CHANGE 1  
TO  
KWM-380/HF-380 SERVICE BULLETIN NO 9

KWM-380 TRANSCEIVER (622-5093-001, -101)  
HF-380 TRANSCEIVER (622-3580-001, -101)  
POWER AMPLIFIER/HEAT SINK ASSEMBLY A1 (634-8481-003)  
POWER AMPLIFIER CIRCUIT CARD ASSEMBLY A1A1 (638-6775-001)

### STOP PA OSCILLATIONS AND ADJUST CIRCUIT GAIN

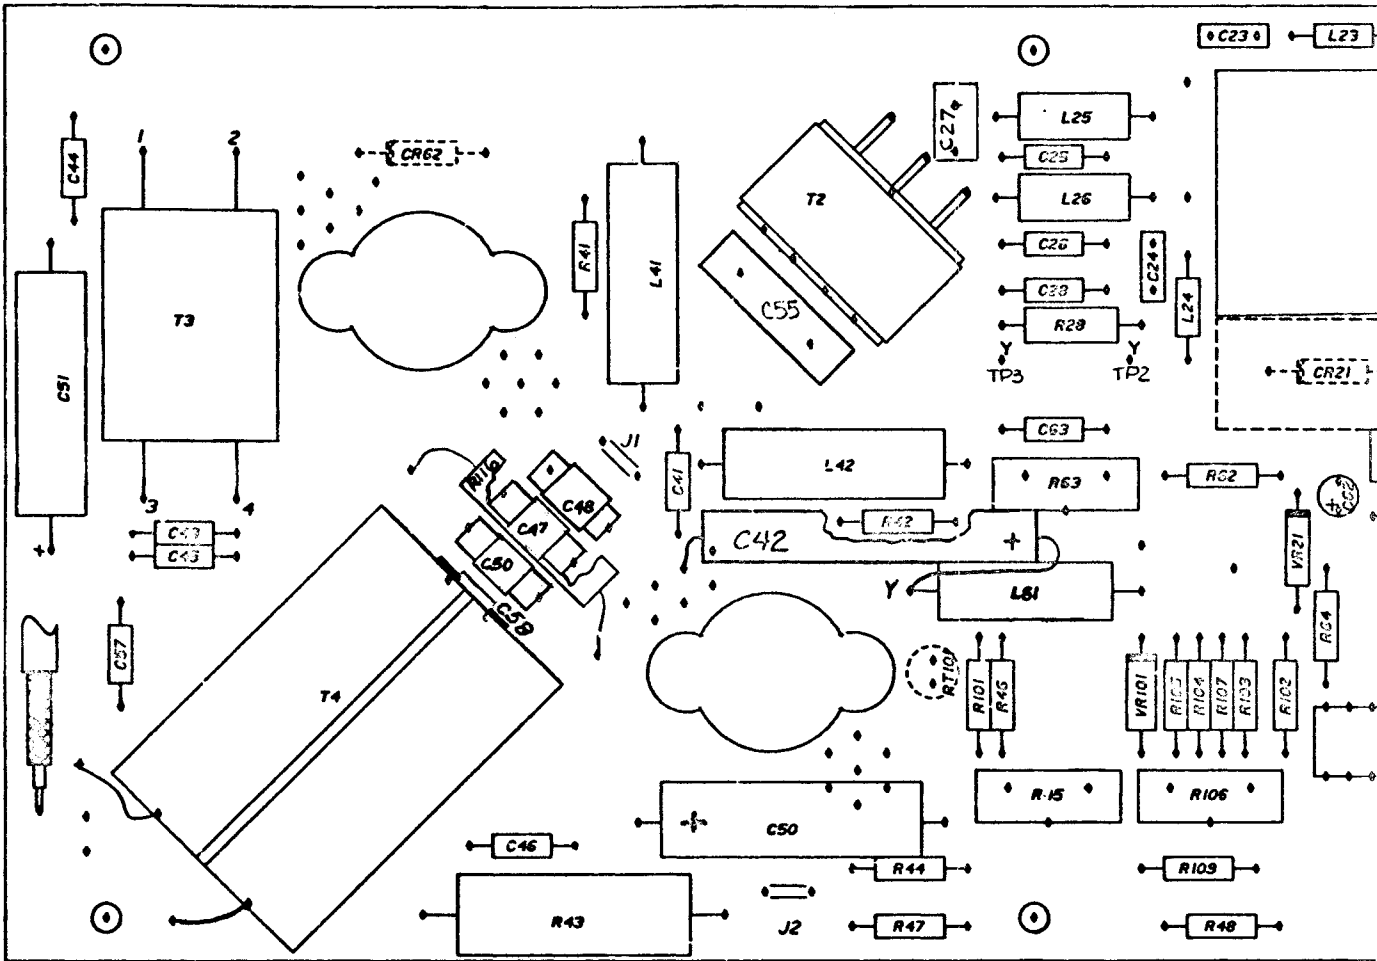
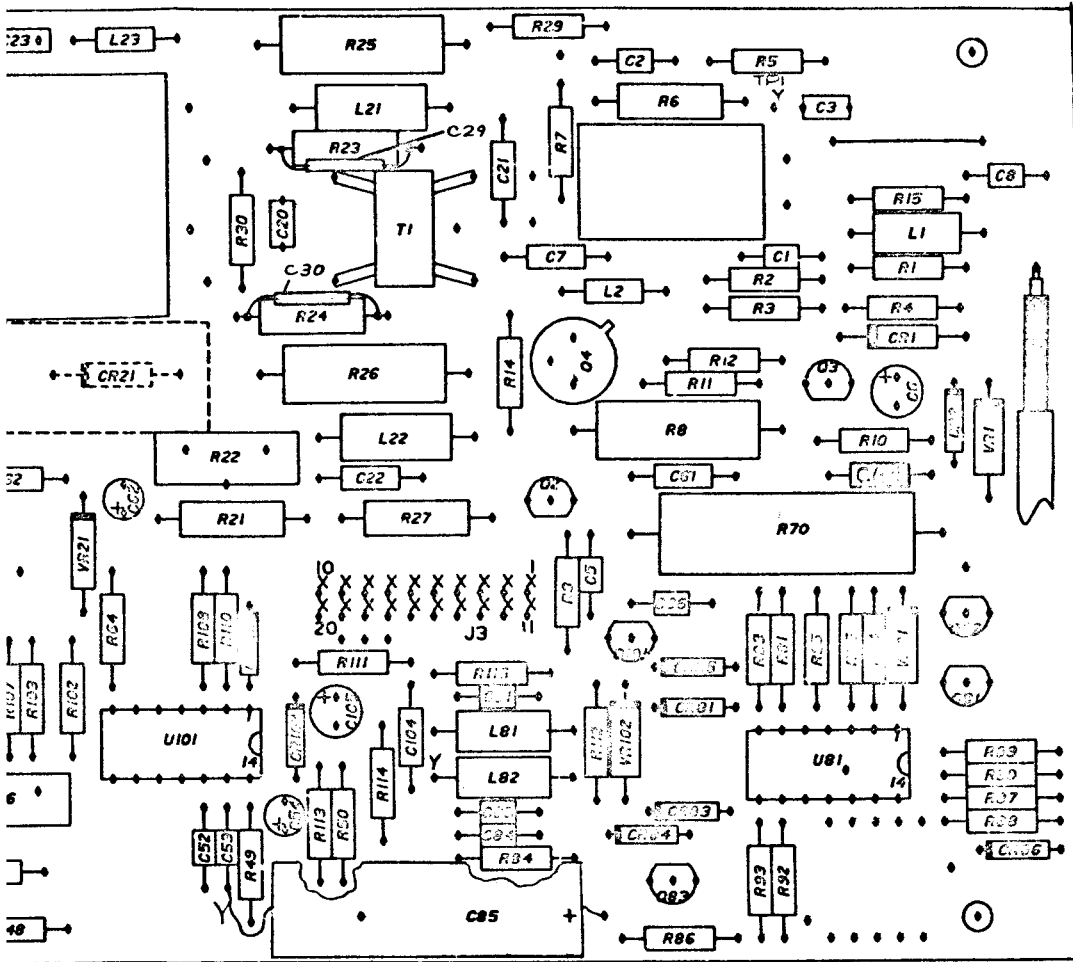
- E. Remove 1500-pF capacitor C55 by cutting the leads close to the body of the component. Leave the capacitor leads soldered into the circuit card.
- F. Install a 1000-pF capacitor (912-3315-000), connecting the leads to the leads of the capacitor removed in step E.
- G. Install a 2.7- $\mu$ H coil L44 (240-2715-180) as shown in figure 1, detail A.
- H. Remove 0.27- $\mu$ H inductors L23 and L24 by cutting the leads close to the component body. Leave the inductor leads soldered into the circuit card.
- I. Install two 3.3- $\mu$ H inductors (240-2029-000), connecting the leads to the leads of the inductors removed in step H.
- J. Install 100- $\Omega$  resistor R123 (745-1310-000) in parallel with L23. Wrap the resistor leads around the coil leads and solder.

- K. Install 100- $\Omega$  resistor R124 (745-1310-000) in parallel with L24. Wrap the resistor leads around the coil leads and solder.
  - L. Examine transistors Q41A/B and resistor R7. If Q41 was manufactured by Motorola, the value of R7 should be 15  $\Omega$ . If Q41 was manufactured by CTC, the value of R7 should be 27  $\Omega$ . If it is necessary to replace R7, cut the resistor leads close to component body, leaving the leads soldered into the circuit card. Install the new resistor (15  $\Omega$ , 745-0683-000, or 27  $\Omega$ , 745-0692-000), attaching the leads to the old resistor leads.

- M. Install a wire (421-2020-000) in parallel with resistor R23. Wrap the ends of the wire around the R23 leads and solder.
  - N. Install a wire (421-2020-000) in parallel with resistor R24. Wrap the ends of the wire around the R24 leads and solder.

- O. Remove 40.2-k $\Omega$  resistor R93 by cutting the leads close to the body of the component. Leave the leads soldered into the circuit card.
  - P. Install a 44.2-k $\Omega$  resistor (705-1075-000) attaching the leads to the leads of the resistor removed in step O.

Power Amplifier A1A1,  
After Modification  
Figure 1 (Sheet 2)

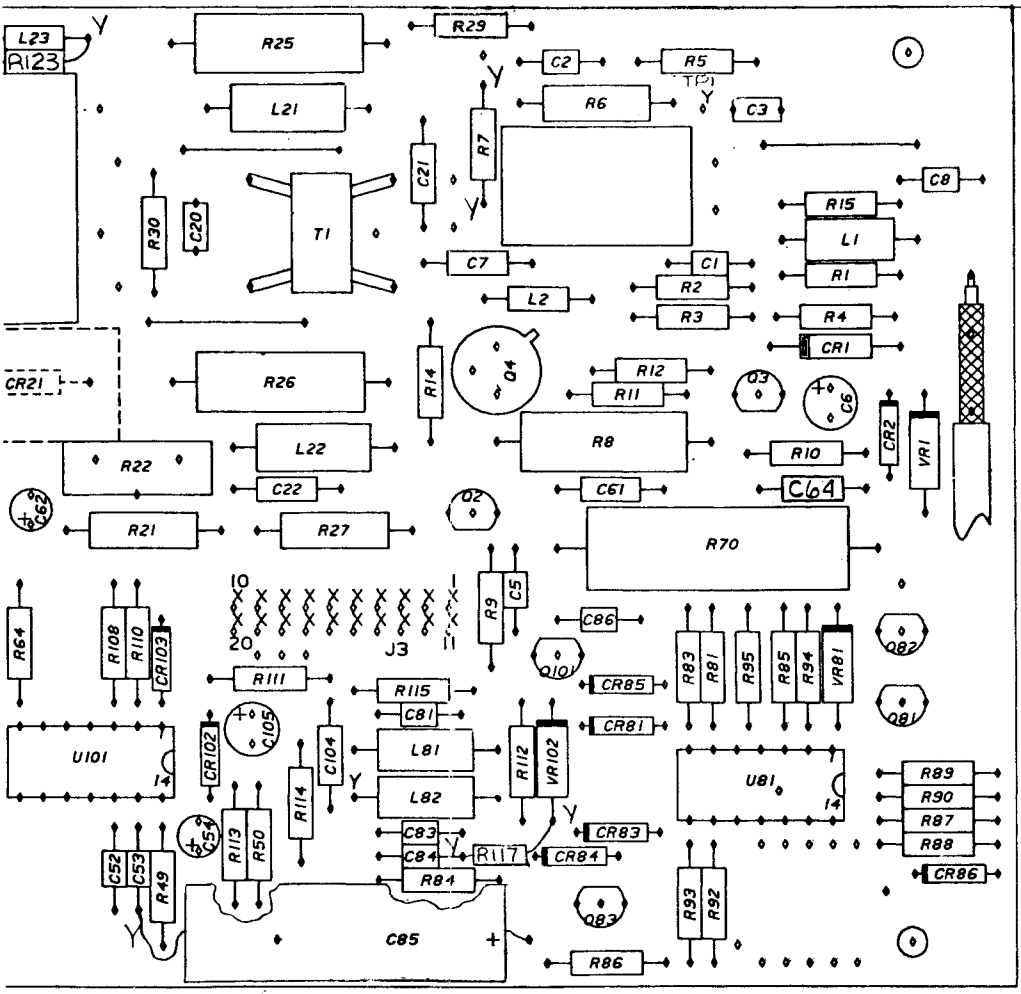
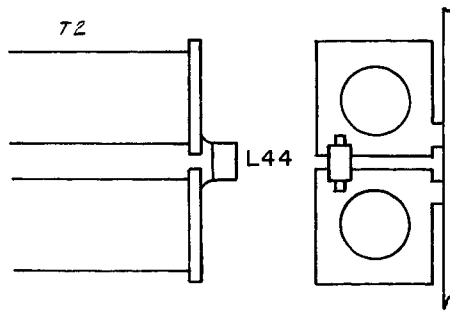
NOTE: Do not remove circuit card A1A1 from power amplifier/heat sink assembly A1. Refer to figure 1 while performing steps E through T. Refer to figure 2 for a schematic diagram of the latest configuration.

- Q. Remove and discard 68- $\Omega$  resistor R116.
  - R. Install electronic components assembly A1A2 (647-2781-001) onto the circuit card as shown in figure 1 using the existing hardware.

- S. Wind two turns of brown wire (422-0795-000) in transformer T3 as shown in figure 1, detail B. Connect to A1A2 assembly as shown in figure 1, detail D. If the transformer core has potting in the holes, carefully clear a way for the brown wire, using a stiff wire such as a straightened paper clip.

DETAIL D

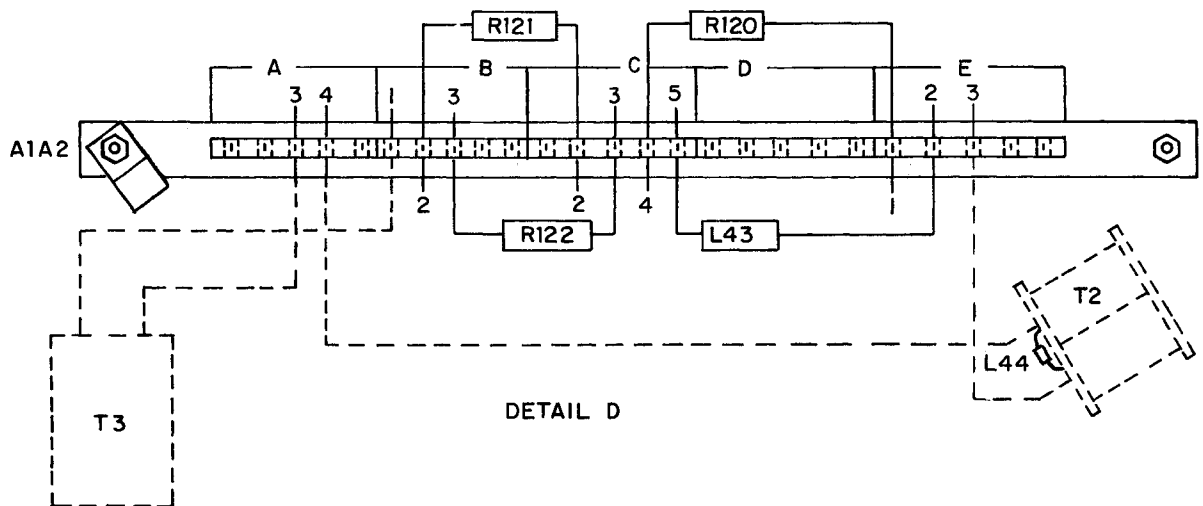
1. Page 1, serial number effectivity table: TBD is replaced by serial numbers.
2. Pages 9/10: Figure 1, sheet 3, was revised to show the correct circuit connections of transformers A1A1T2 and A1A1T3.

- T. Wind two turns of red wire (442-0796-000) in transformer T2 as shown in figure 1, detail D. If necessary, clear the core of potting as in step S.

- NOTE: The added wires in steps S and T must be oriented as shown in figure 1, details B and C, to prevent oscillation.
- U. Reassemble the transceiver in the reverse order of disassembly.

NOTE: LEADS FROM T2 AND T3 MUST BE CAREFULLY POSITIONED AS SHOWN TO PREVENT DESTRUCTIVE OSCILLATION.
